Southern California Edison Company
SAN ONOFRE NUCLEAR GENERATING STATION
P O BOX 128
SAN CLEMENTE, CALIFORNIA 92672

Subject: Follow-Up Activities Associated with NRC-IIT Investigation
San Onofre Nuclear Generating Station, Unit 1

3. Proposed Facility Change (PFC)/Design Change Package (DCP) 1-85-3052.OTJ. Rev. 0 (Main Control Room Indication of Main Feedwater Low Flow)

Description PROVIDE MFW LOW FLOW INDICATION IN THE MCR TO ENHANCE OPERATOR ADMINISTRATIVE CONTROL TO PREVENT WATER HAMMER WHEN THE FEEDRING IS UNCOVERED.

LOCATION PLAN @ 14'-0

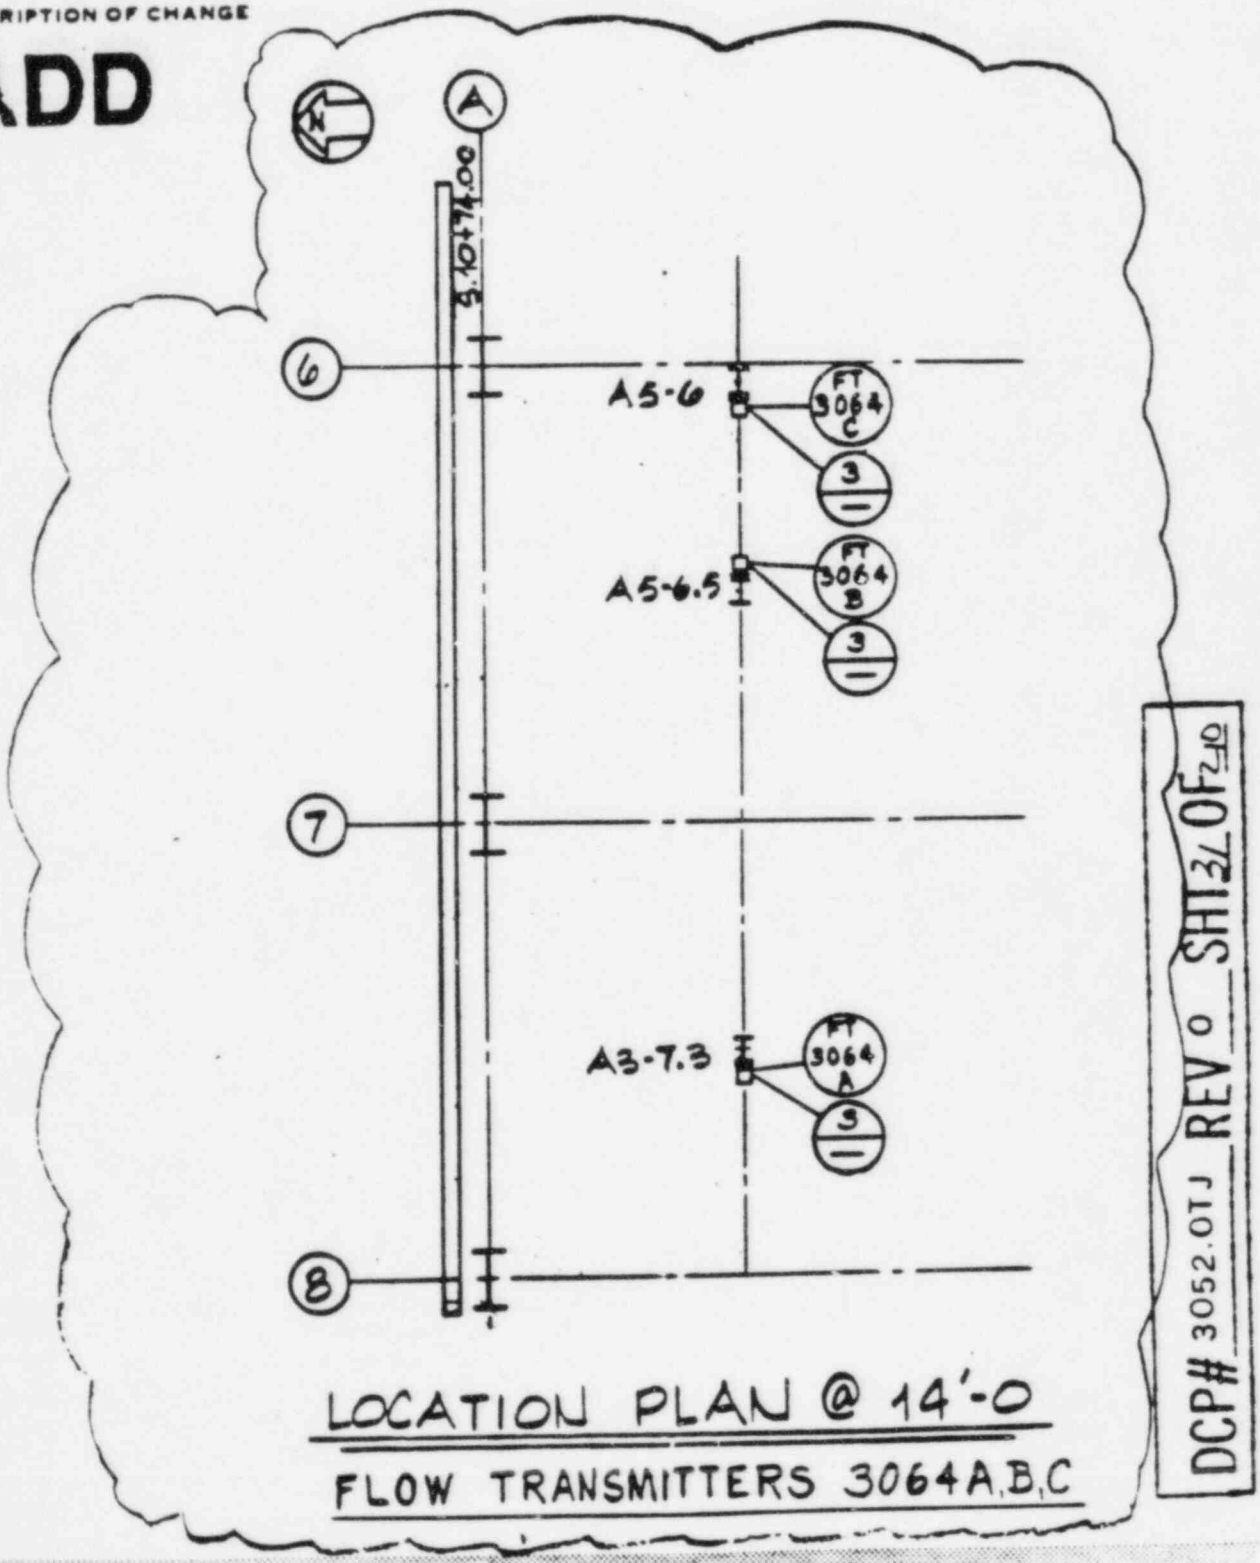
ADD

PLAN @ PLATF. EL. 30'-0

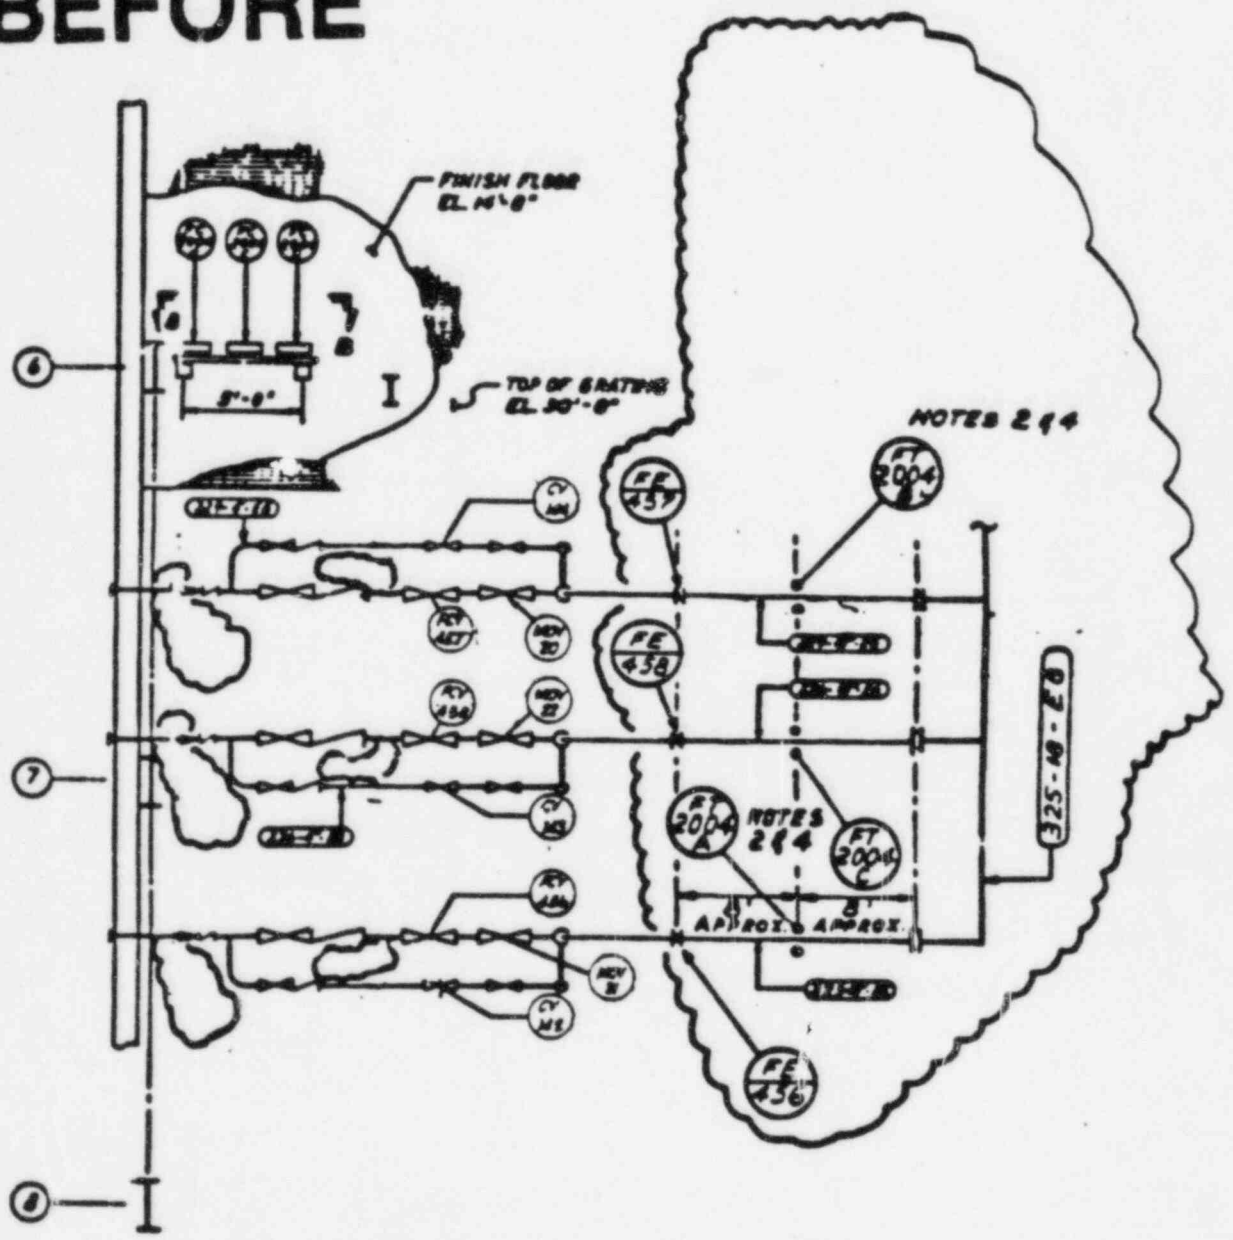
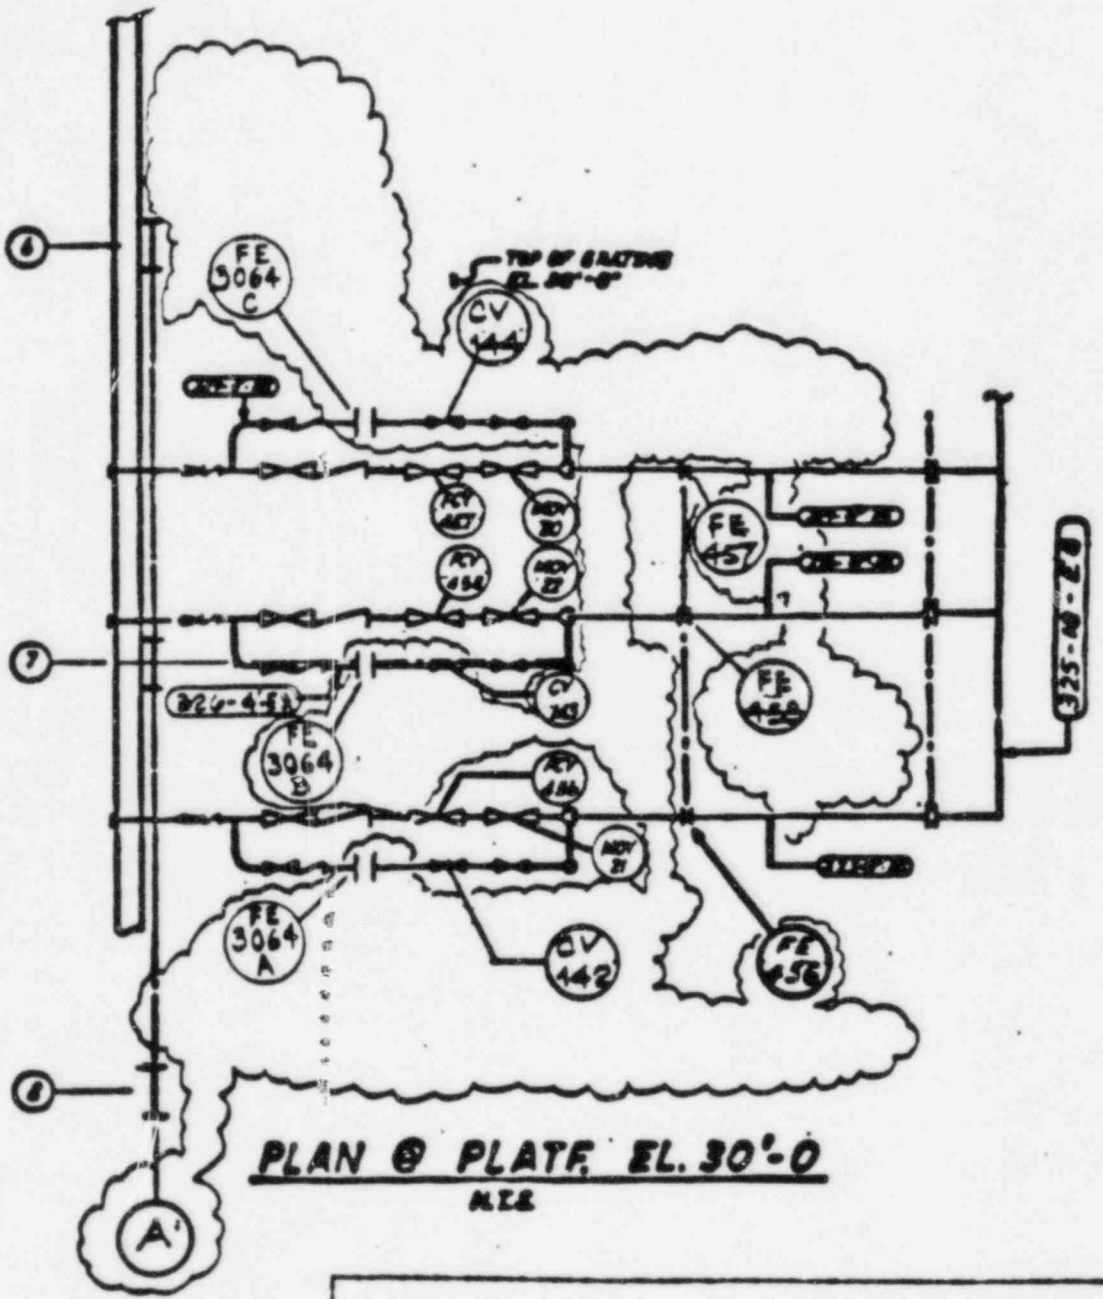
1. PROVIDED FIELD NOTES (PAGE 2)
2. ADD LOCATION PLAN @ EL. 14'-0 (PAGE 3)
3. REVISE PLAN @ EL 30'-0 (BEFORE - PAGE 4; AFTER - PAGE 5)
4. REVISE DETAIL 1 (BEFORE - PAGE 6; AFTER - PAGE 7)
5. ADD DETAIL 3 (PAGE 8)
6. ADD DETAIL 4 (PAGE 9)
7. REVISE SECTION "B-B" (BEFORE - PAGE 10; AFTER - PAGE 11)
8. REVISE NOTES (BEFORE - PAGE 12; AFTER - PAGE 13)
9. REVISE REFERENCE DRAWING BLOCK (PAGE 14)
10. REVISE TITLE BLOCK (PAGE 15)
11. ADD BILL OF MATERIALS FOR DETAILS 1 & 3 (PAGE 16)

ISOMETRIC DETAIL 3/1

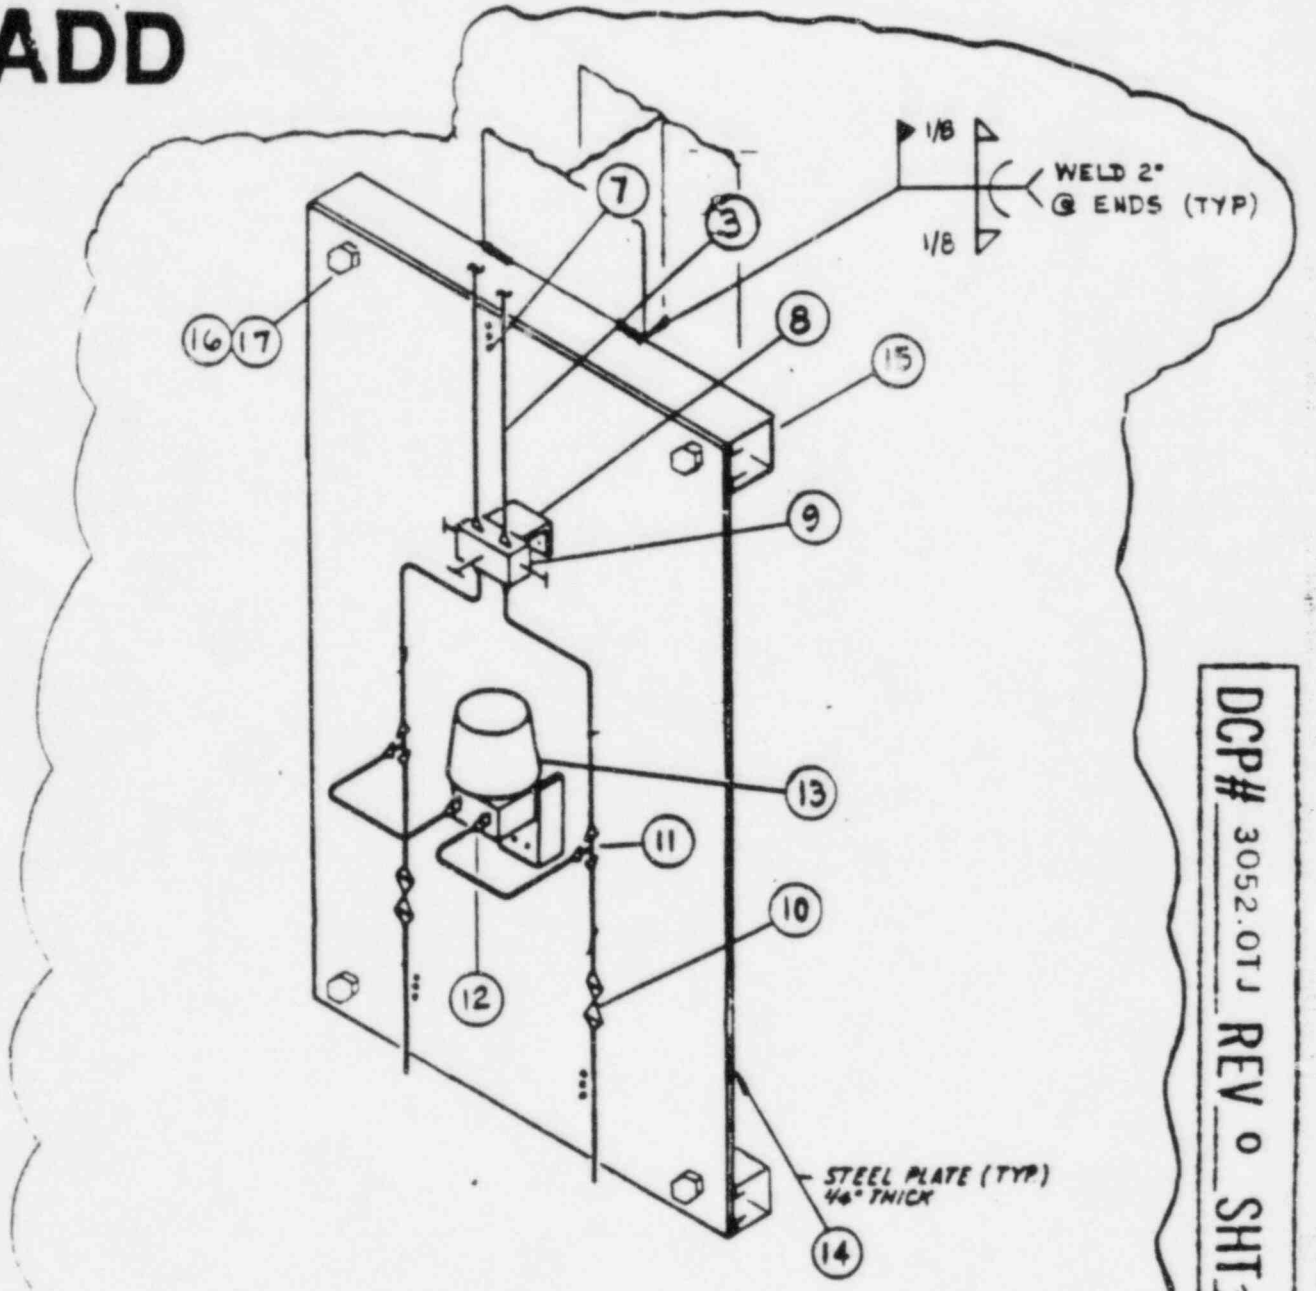
ADD

DCP# 3052.0TJ REV 0 SHT 42 OF 210

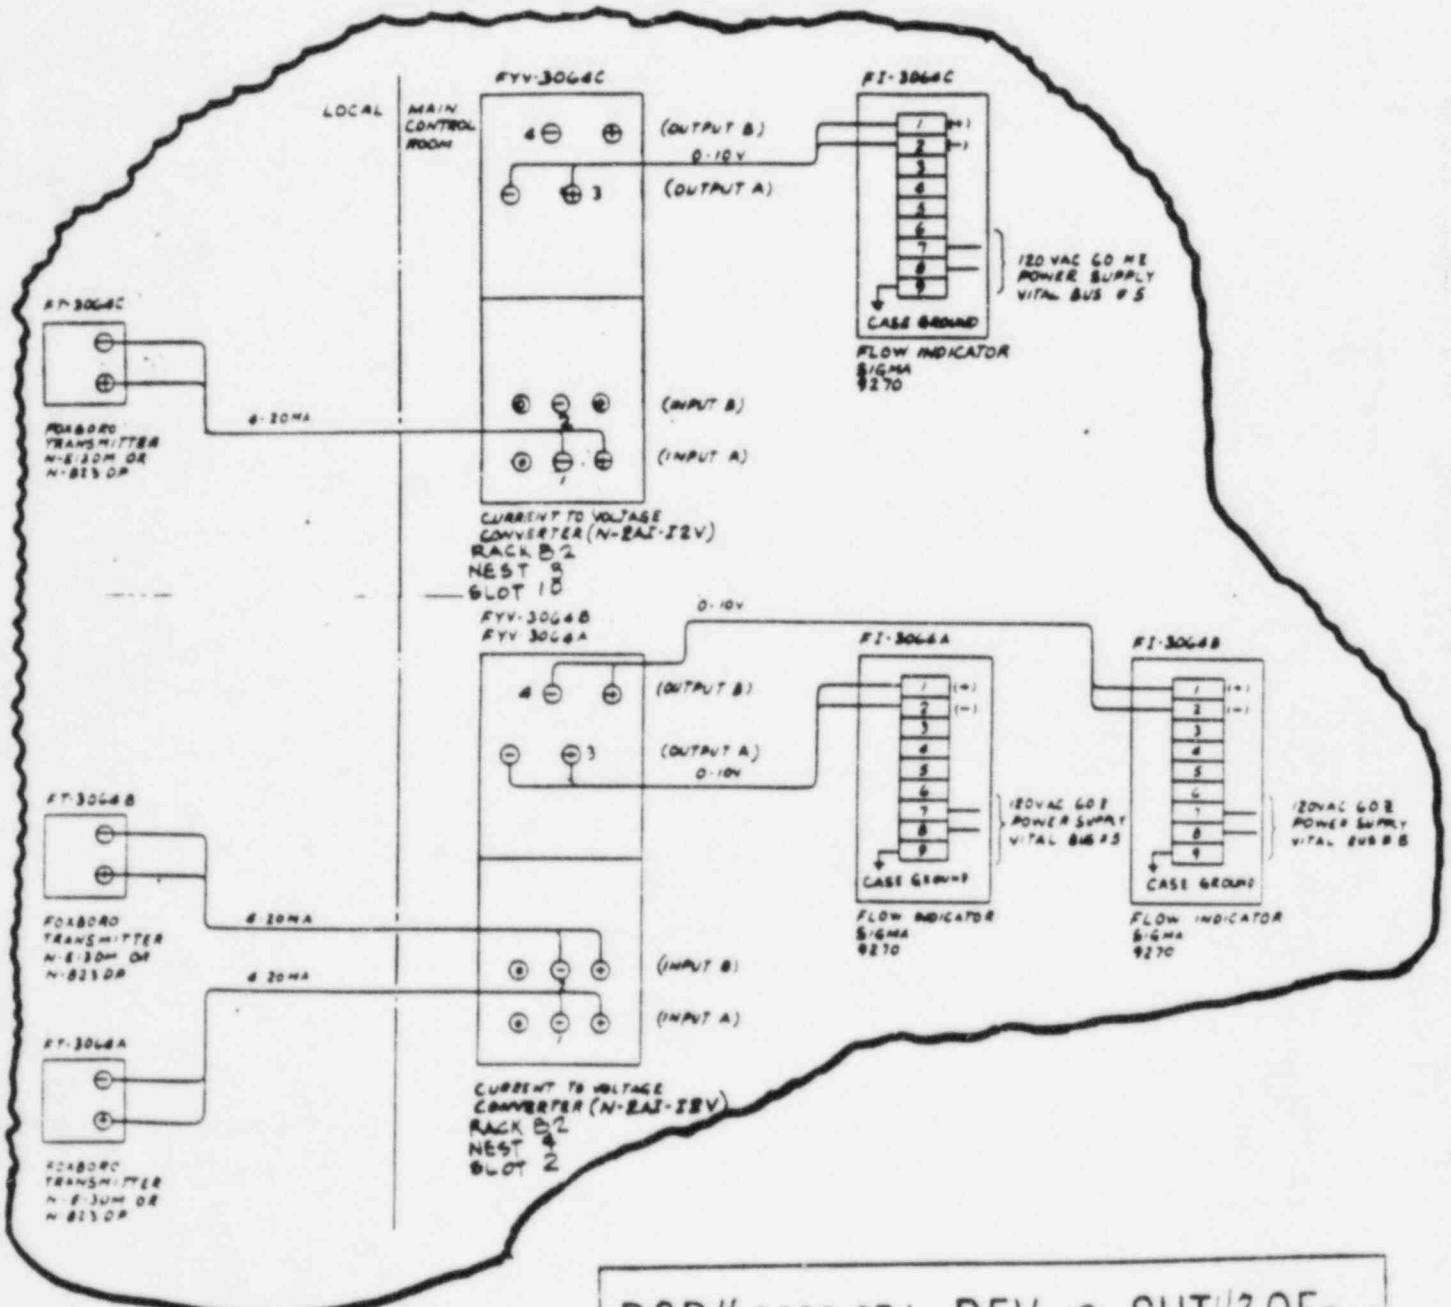
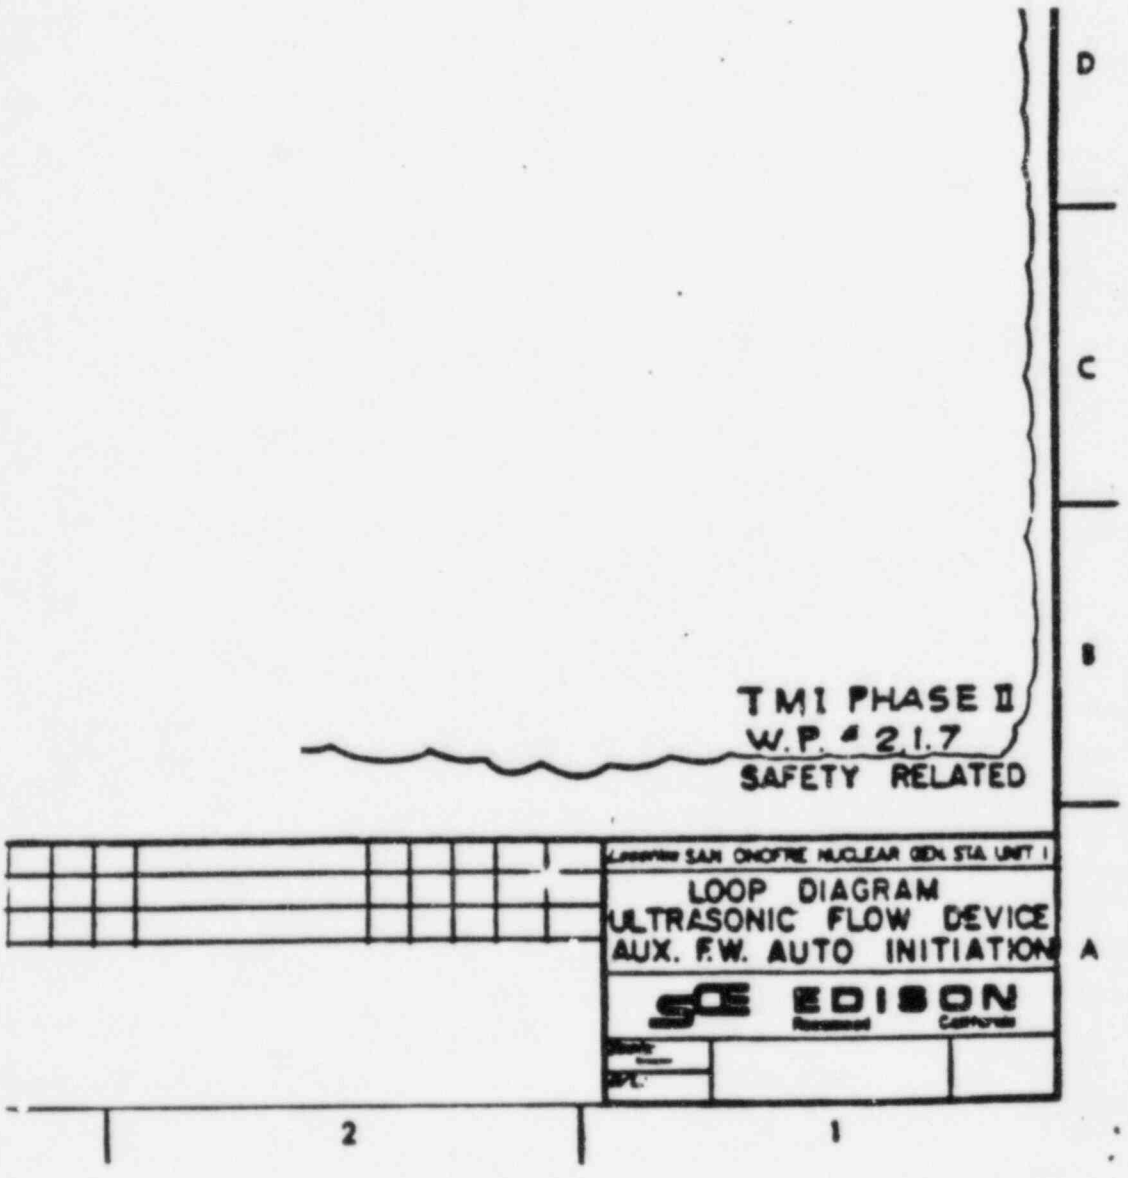
REVISE DRAWING 451337 TO INCORPORATE MFW LOW FLOW INDICATION
